CITY OF SACRAMENTO

Permit No: 0203814

Site Address: 6579 SUNNYFIELD WY SAC

Nature of Work: MP 1593 1 STORY 7 ROOM SFR

Preliminary Residence 3

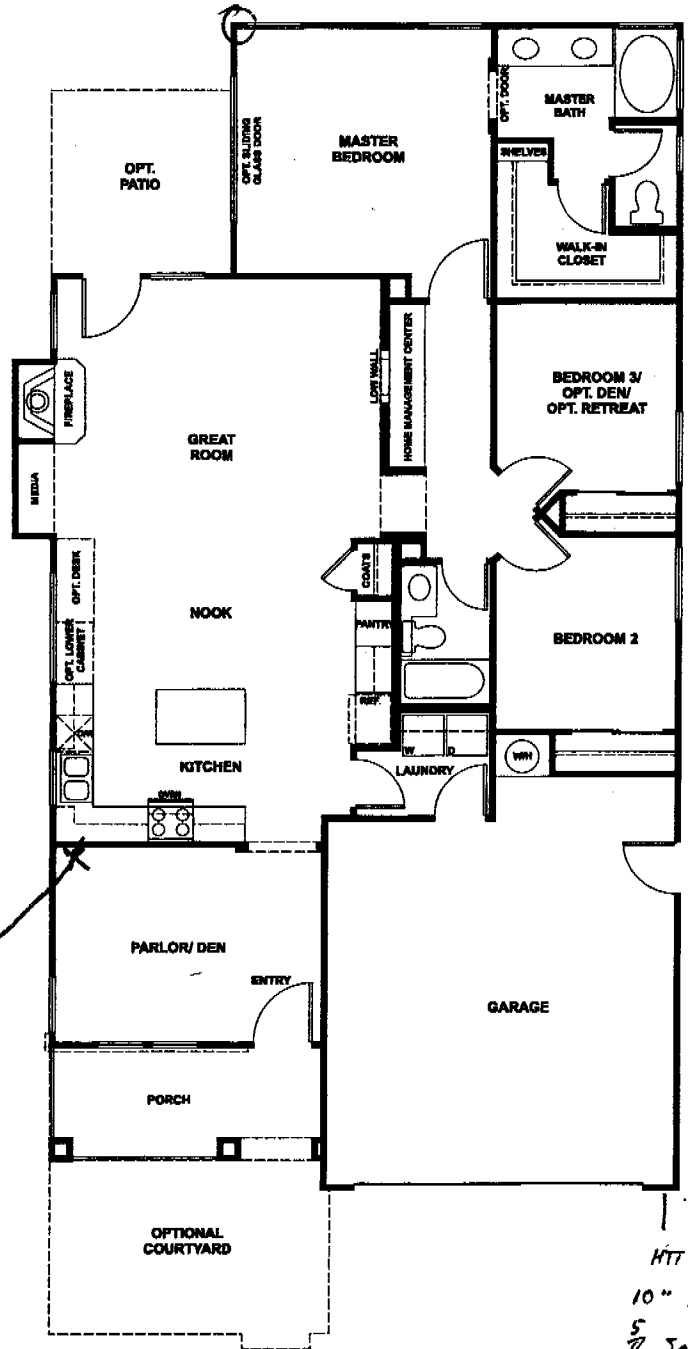
- Observed Epoxy Installation of; Performed proofload tests on; Hold Down's MISSED lots # 30-31-32
for _____
installed at lots 30-31-32 See attached map & list + fix for SPL'S & locations
1- HIT - 22 lot 31 2- HIT - 22 lots # 30 & 32 ea 5 total

HTT-22
10" Embed
5/8 307 ROD

ANCHOR BOLT REPLACEMENT DETAIL

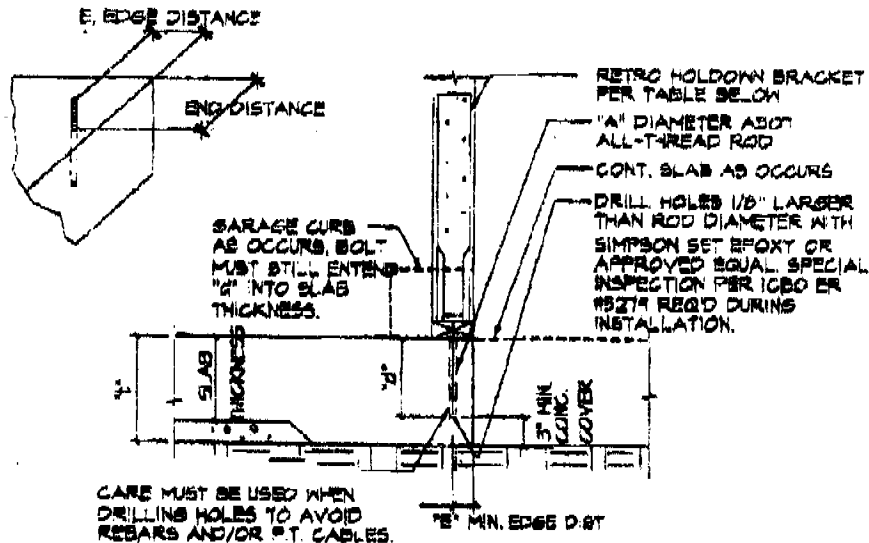
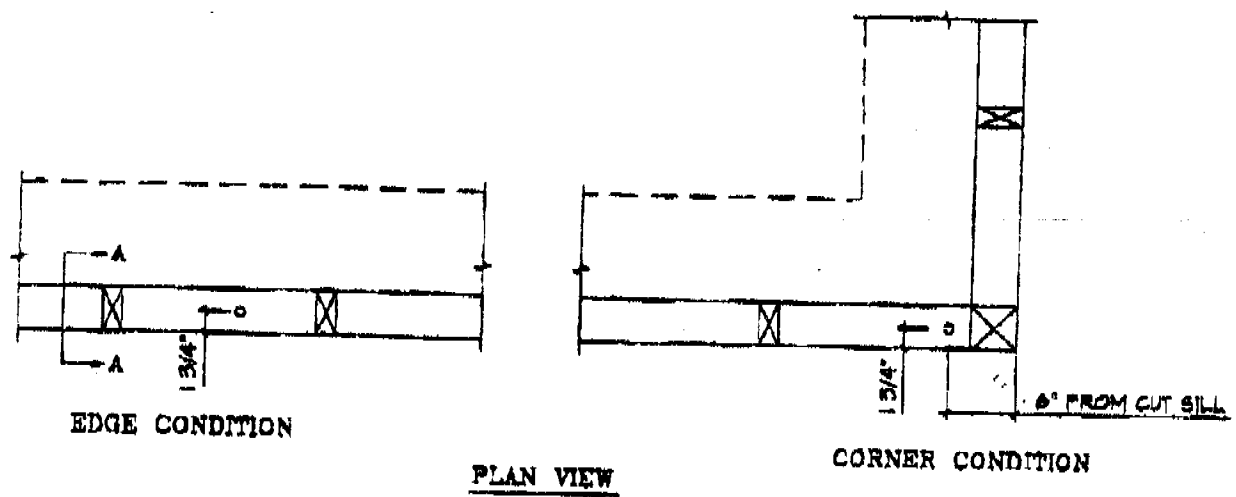
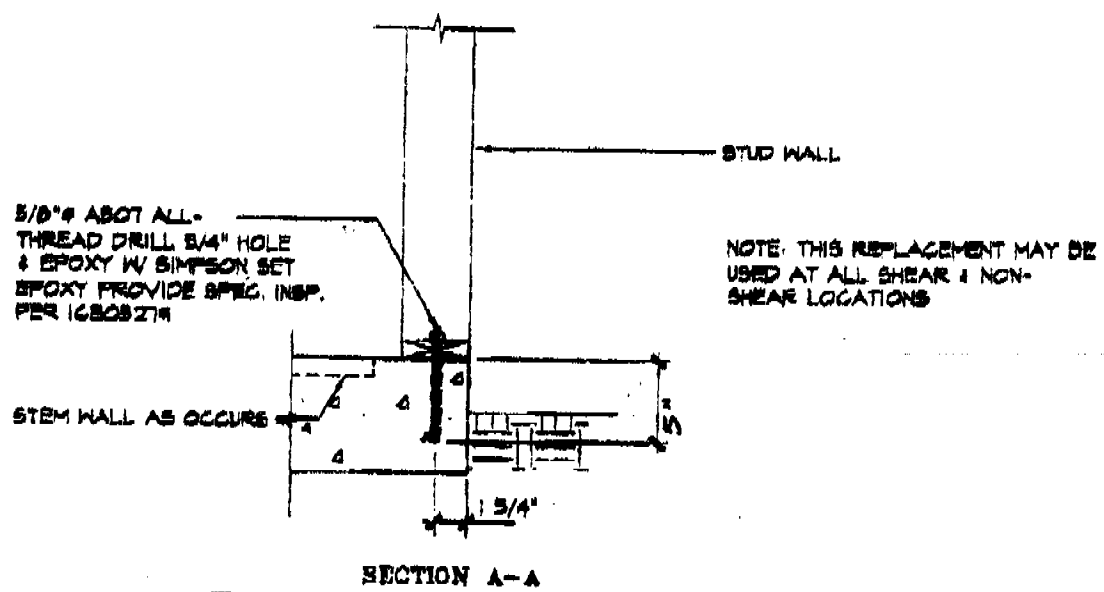
The following may be used to replace missing or incorrectly installed sill plate anchor bolts into existing concrete:

- I. The anchor bolts specified on the plans may be substituted with ITW Ramset/Red Head Carbon Steel or Stainless Steel Trubolt Wedge anchors (ICBO no. ER-1372). The minimum embedment depth into concrete shall be 5.125" for 5/8" diameter bolts or 6.625" for 3/4" diameter bolts. This anchoring system may be used with the following restrictions:

- a) The anchor bolts on the plans may be substituted with an equal number and diameter of Wedge anchors provided the distance from the concrete edge to the anchor is greater than 7".

- b) Where the concrete edge distance is at least 2" (5/8" diameter bolts only), equal diameter anchor bolts may be substituted. However, the number of anchor bolts must be doubled. The minimum center-to-center spacing of the anchors shall be 8". Minimum anchor edge distance from the mud sill plate for 5/8" anchors is 1".

- c) Where the concrete edge distance is at least 2.5", all 5/8" diameter anchor bolts specified on plans may be substituted with 3/4" diameter wedge anchors of equal numbers. Minimum edge distance from the mud sill plate for 3/4" anchors is 1.25".

- II. As another alternative, anchor bolts on plans may be substituted with equal diameter and number if the following system is used:
- a) Simpson RFB anchors installed in hole size of anchor diameter plus 1/8". Install with Simpson SET (ICBO no. ER-5279). Minimum depth of anchor into concrete shall be 5" for 5/8" diameter anchor or 6.75" for 3/4" diameter anchor. Minimum concrete edge distance shall be 1.75". All installations of this type require special inspection.

MAIN FLOOR PLAN
SCALE: 1/4" = 1'-0"
-PM

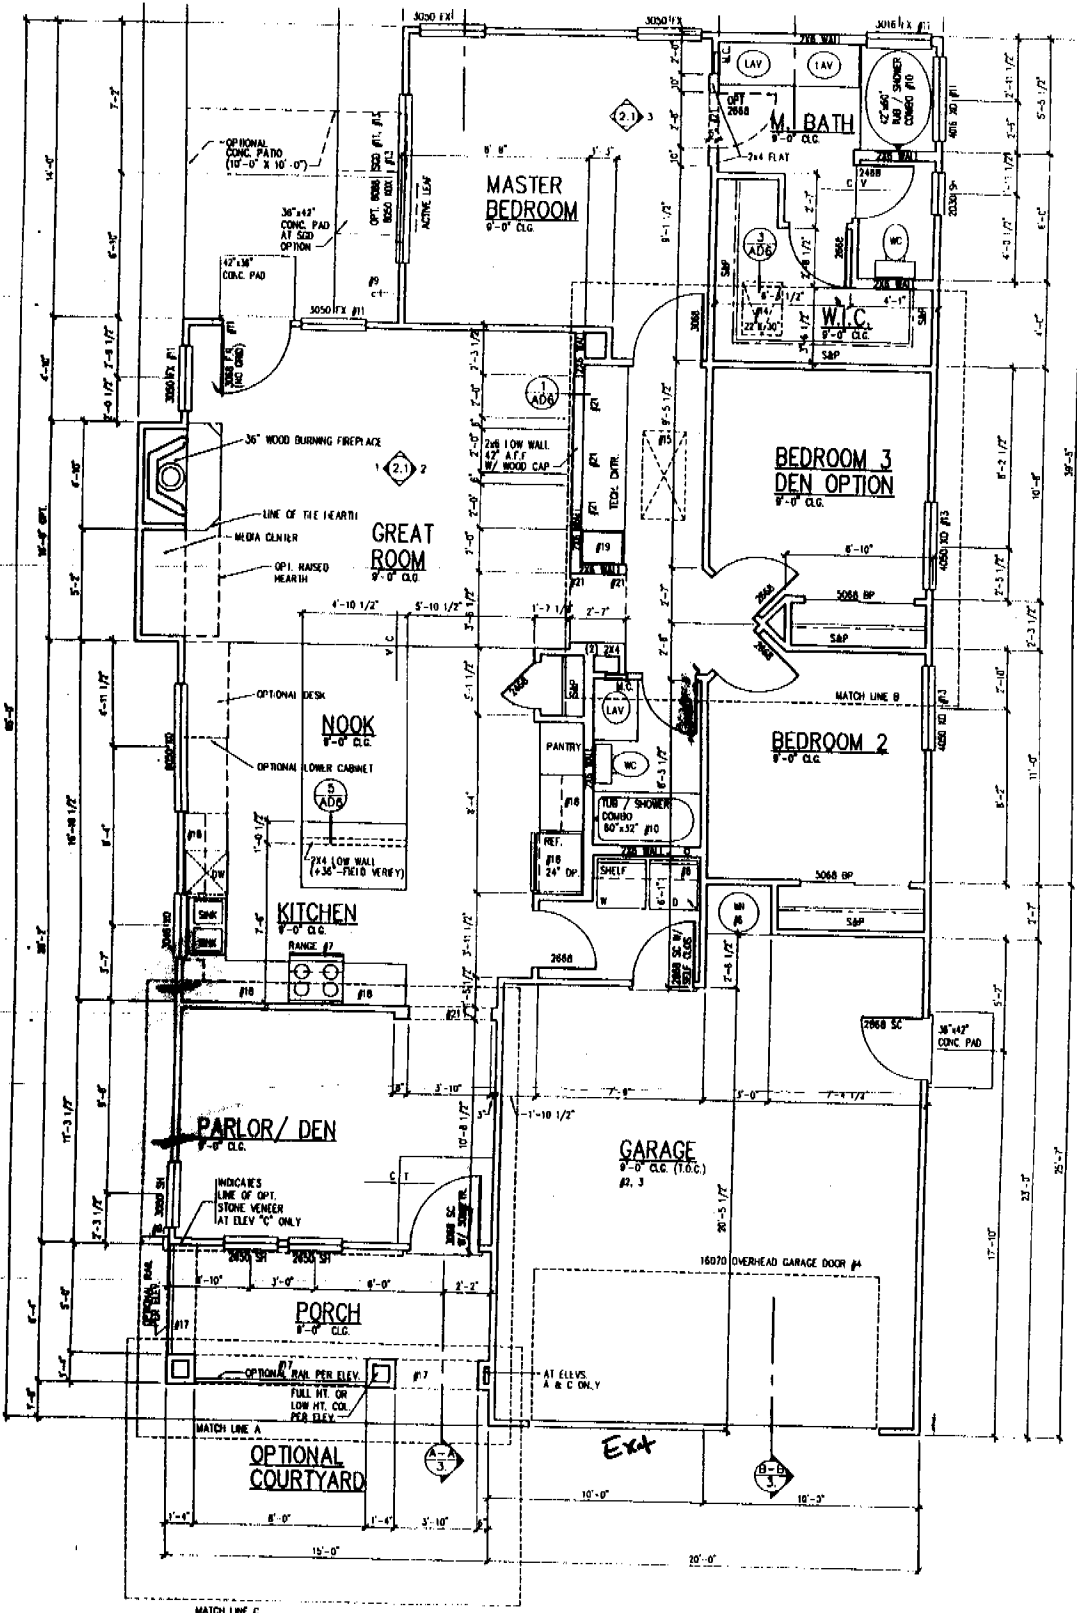
1. Observed Epoxy Installation of; Performed proofload tests on; Anchors installed to 7" embedment
per plans at lot 30 see floor plan for location
installed at _____

bolts installed at
Highlighted marks

RICHMOND LAGUNA CLASSICS LOT 30-3C

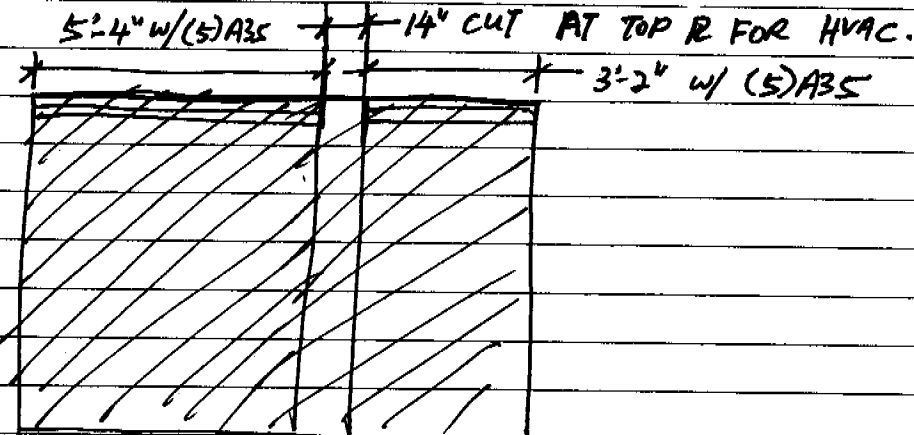
A "P3" SHEAR WALL AT LINE 1 ONLY REQUIRE A MINIMUM LENGTH OF 8'-6".

B. IT IS FINE TO HAVE SITUATION AS SHOWN FOR P2 SHEAR WALL AT LINE B.
